From: Hoellman, Jordan
Sent: Wednesday, August 29, 2018 1:14 PM
To: Vogle PEmails
Subject: LAR 18-021 Post-Submittal Presentation
Attachments: 2018-08-30 LAR-18-021 PSM Slides.pdf

VEGP 3&4 LAR-18-021 (WEC LAR-211): Power Operated Relief Valve (PORV) Noise Mitigation

August 30, 2018

Current vs Proposed Design

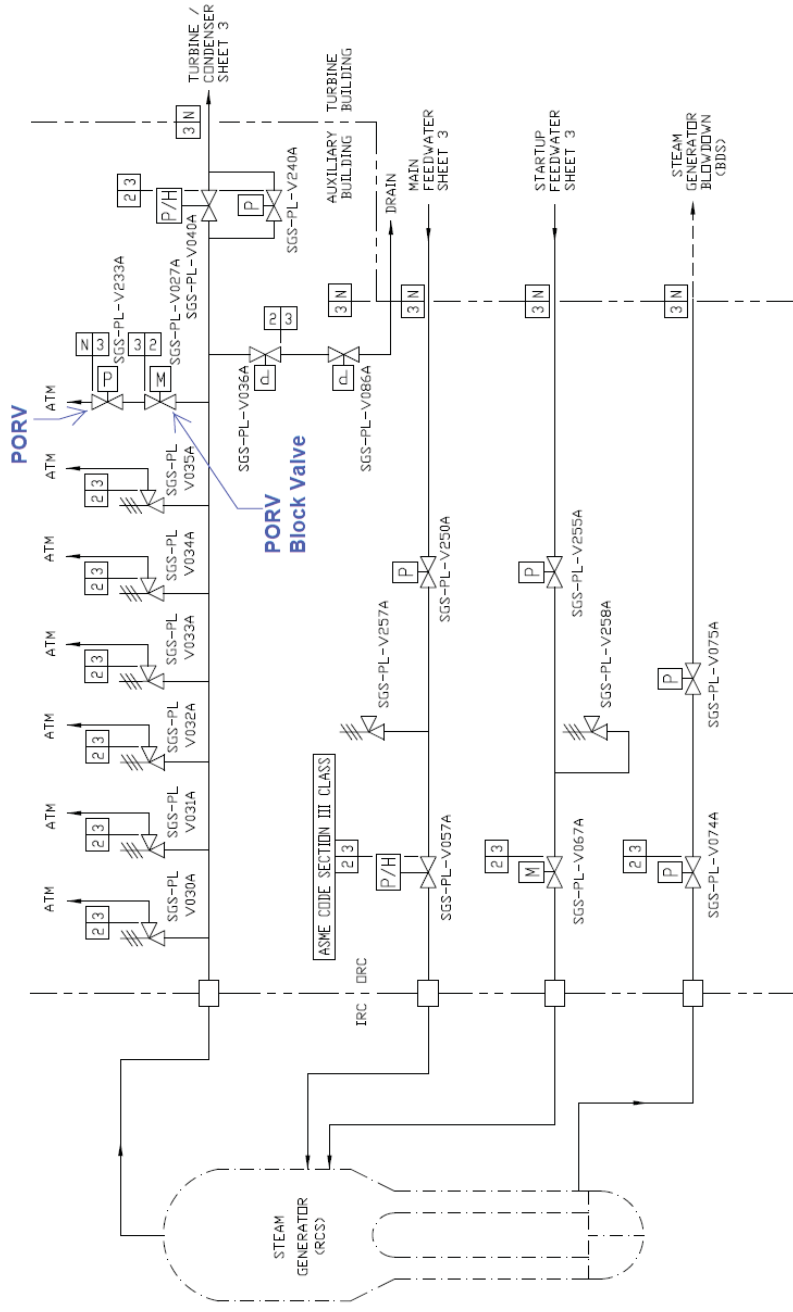
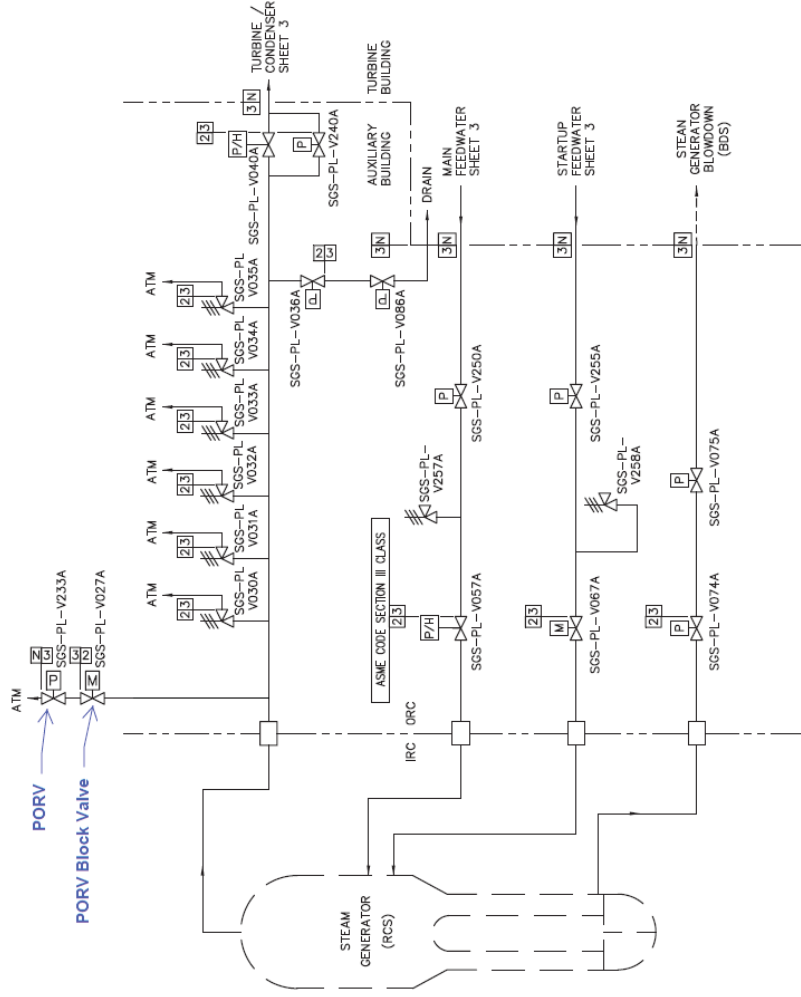
- The current design has one 6" branch line off of each main steam lines, through a 6" block valve (gate type), to each PORV.
- A 6" branch line comes off each main steam line downstream of the main steam safety valves (MSSVs) and upstream of the main steam isolation valve (MSIV).

- The proposed design has one 12" branch line off of each main steam lines, through a 12" block valve (globe type), to each PORV.
- The 12" branch line comes off each main steam line upstream of the main steam safety valves (MSSVs) and upstream of the main steam isolation valve (MSIV).
- The PORV is unchanged

- Relocate the PORV branch line to upstream of the MSSVs:
 - Tier 1 and COL Appendix C Figure 2.2.4-1 Sheets 1 and 2: Depict PORV branch lines as upstream of MSSVs
 - Tier 2 Table 6.2.3-1: Reduce pipe length between containment and PORV block valves
 - Tier 2 Figure 10.3.2-1: Depict PORV branch lines as upstream of MSSVs
- Change PORV block valve type from gate valve to globe valve
 - Tier 2 Table 3.9-16
 - Tier 2 Figure 10.3.2-1
